# Mixed Low-Level Radioactive and Hazardous Waste Disposal Facilities

Review and Comparison by  
John R. Brodeur, P.E., L.E.G.  
Energy Sciences & Engineering  
Kennewick, WA

Comments on Hanford  
Facilities & Background  
Prepared by  
Heart of America Northwest  
1314 NE 56th St., #100  
Seattle, WA 98105

March 2006

Fig. 3.2.2

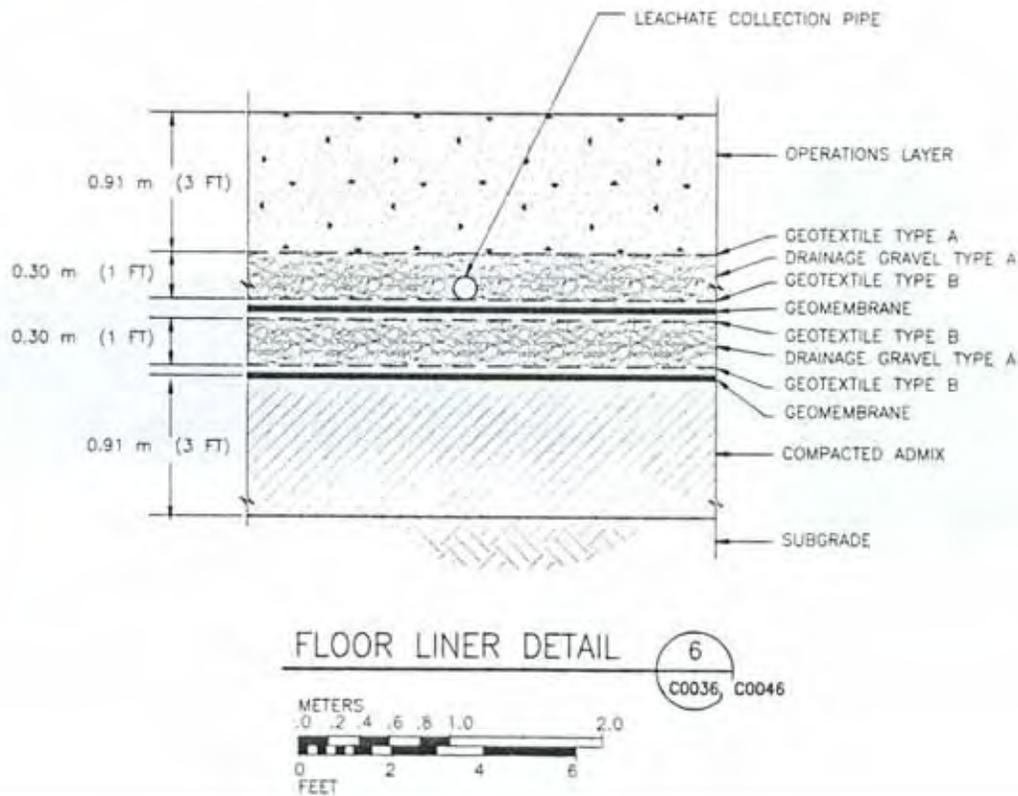
The liner was then constructed on top of the compacted sub grade. A schematic of the ERDF liner is shown in Figure 3.2.2.

**Fig. 3.2.3 Typical Hanford Site Landfill Cover Design**

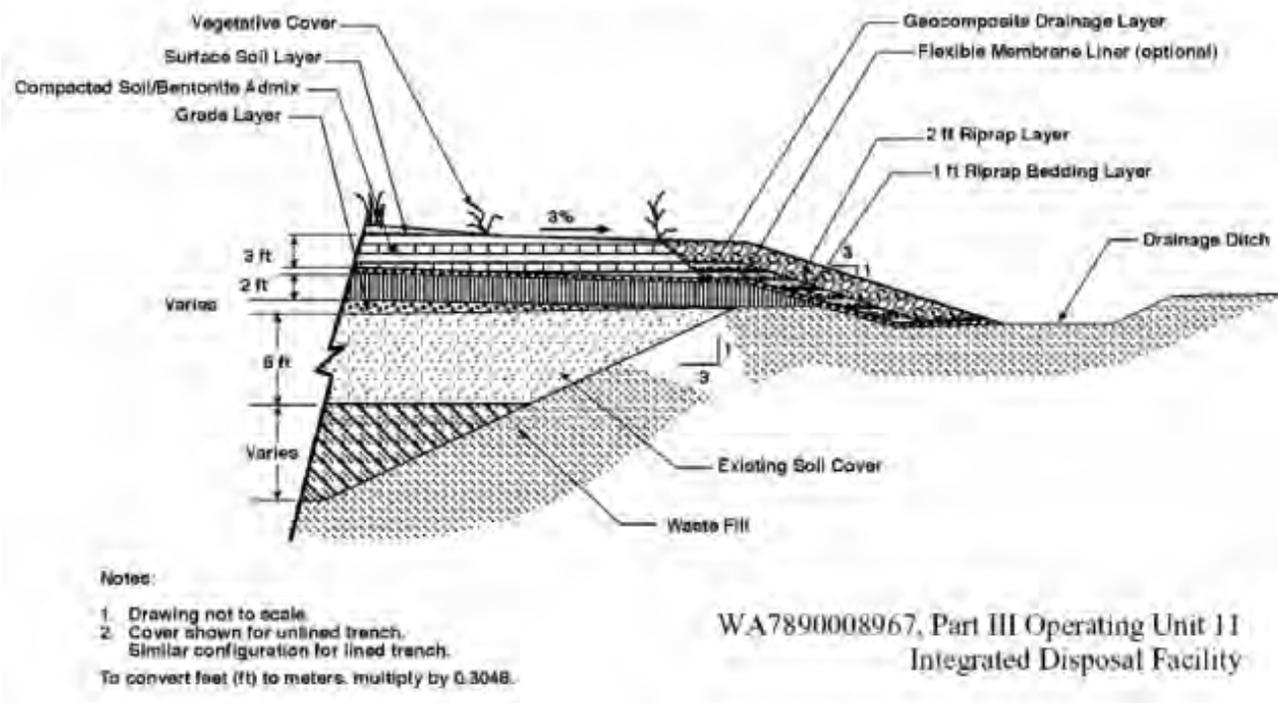
The cover system design has not yet been finalized. However, the ROD indicates that the cover will be either a RCRA compliant cover or a modified RCRA cover. The modified RCRA cover adds features such as a layer of rip-rap rock to help deter intrusion into the waste and features such as an infiltration barrier designed to enhance evapotranspiration in the Hanford climate.

**Fig. 3.3 Integrated Disposal Facility Site Plan**

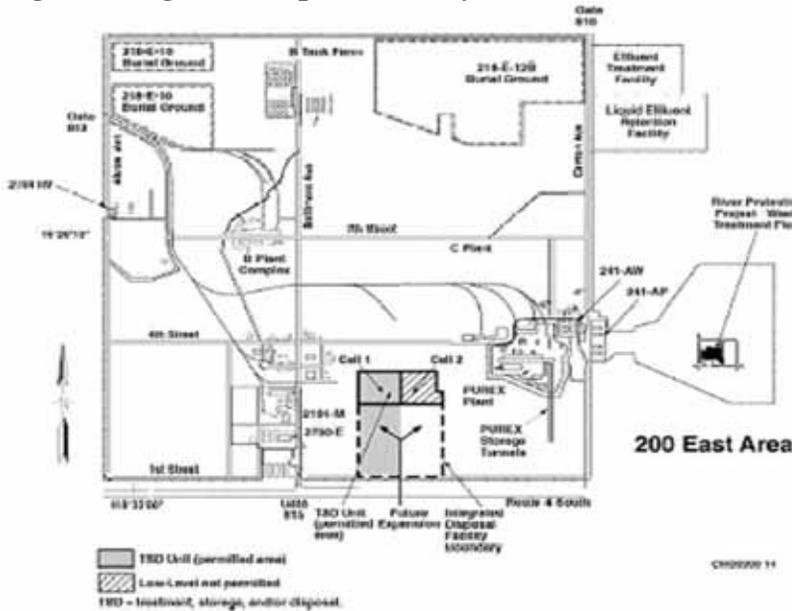
The USDOE’s proposed Integrated Disposal Facility (IDF) is currently under construction in the 200 East Area at Hanford (see Figure 3.3). This facility is a combination of two identical disposal cells sitting side-by-side and referred to as the East Cell and the West Cell. Figure 3.3 provides the only site plot that could be found for the IDF because maps and schematics were redacted from the Ecology permit application (presumably due to USDOE request for security controls intended to mitigate terrorist threats to the facility). This inexplicable redaction of siting and design adds to the difficulty of getting information on this facility, and makes commenting on the permit and impacts more difficult.

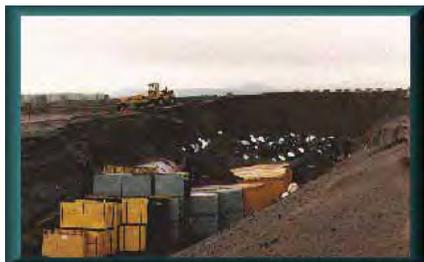
A proper environmental monitoring scheme should include a liner system with leachate collection as a means of monitoring during landfill operations and post closure. If there is a defensible logic to monitoring without using a liner, it has not been disclosed and discussed, and should be the topic of public discussion and

meetings. This is not adequately addressed in the FEIS, or in the response to our comments. It is important to note that HoANW and others urged remedial action to retrieve wastes from unlined portions of the landfill where site investigation indicated contamination has spread, or will spread from. This objective to prevent contamination and remediate existing, documented releases is simply not addressed – and can not be met solely by placing new wastes in cement vaults. The existing disposed wastes will continue to violate these basic standards for early detection.

Alternatives to a liner and leachate monitoring could include installation of an effective vadose zone (VZ) monitoring scheme with some sort of regulatory compliance demonstration criteria. Questions would need to be addressed regarding what level of VZ monitoring is effective and what would be needed for a compliance level monitoring system in spatially heterogeneous soils. It is clear that their current VZ monitoring (3 vapor sampling boreholes) contributes little to the compliance-monitoring objective. All of these concerns have to be explained in the EIS for license approval.
